Subject: Updated Work Plan, June 30, 2015, Addendum #1

Former Outfall 001/1A(CGW) Tioga Avenue BCP Site #C851031

Corning, New York

WORK PLAN FOR THE CHARACTERIZATION AND REMOVAL OF FORMER OUTFALL 001/1A(CGW) AND ASSOCIATED INLET PIPING AND TWO NEARBY INDUSTRIAL STRUCTURES TIOGA AVENUE BCP SITE - #C851031 CORNING, STEUBEN COUNTY, NEW YORK

FIGURE 1

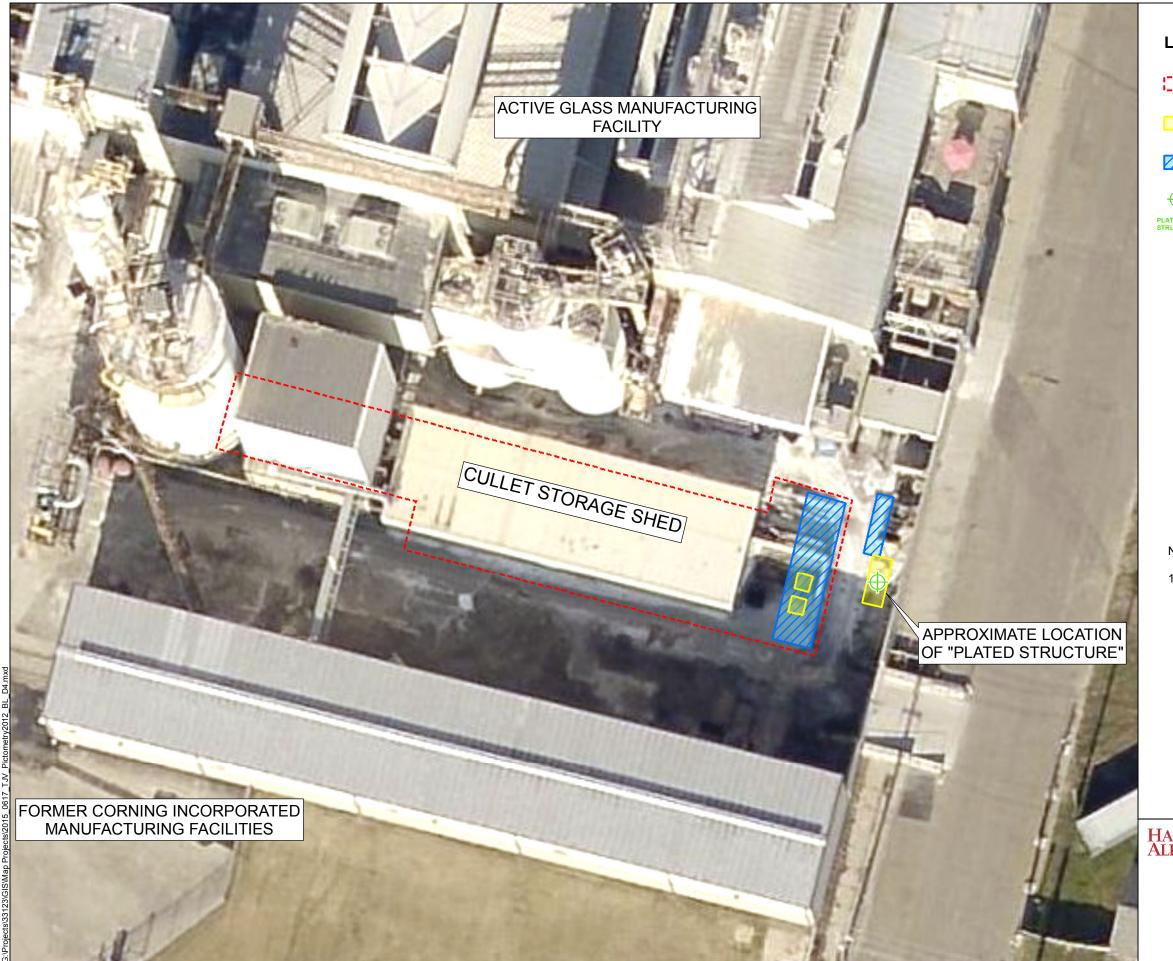
- 1. The pipe leading offsite to the east from the Outfall 001/1A(CGW) structure will not be permanently closed. A removable plug will be placed in the pipe and the structure will be left open until resolution of any remaining potential issues, at which time the structure will be closed by filling to ground surface with flowable fill or concrete as described in the work plan.

- 2. The elevations of the pipes leaving the structure are visible from the structure. Machine excavation for each pipe will be carefully conducted to remove overburden soils to the top or near the top of the pipe while attempting to minimize disturbance of the pipe. The pipes will be uncovered allowing for inspection to determine if there are breaks or offset joints in the pipe that may have been sources of leakage to nearby soils. Pipe condition will be documented and pipes will be removed as described in the Work Plan. If observed based on the monitoring described in the work plan, impacted soil (from an apparent pipe break) will be handled in accordance with this work plan and the SMP for the site.

- 3. The work will be performed in an area of the site designated as low permeability cover. After removal of the structures and piping, onsite excavated suitable soils will be returned to the trench. Any additional material necessary for fill to restore grade will be Item #4 gravel obtained from a dedicated stockpile at the Gridley Excavating South Gravel Mine (NYSDEC Permit #8-4638-00078/0001). This material was previously tested based on applicable soil import protocol and the results submitted to you on August 5, 2014 and approved on August 27, 2014. Final

surface restoration shall be asphalt pavement installed in accordance with the detail labeled "Low Permeability Cover or Standard Duty - Asphalt Option", shown on Figure 11 of the SMP.
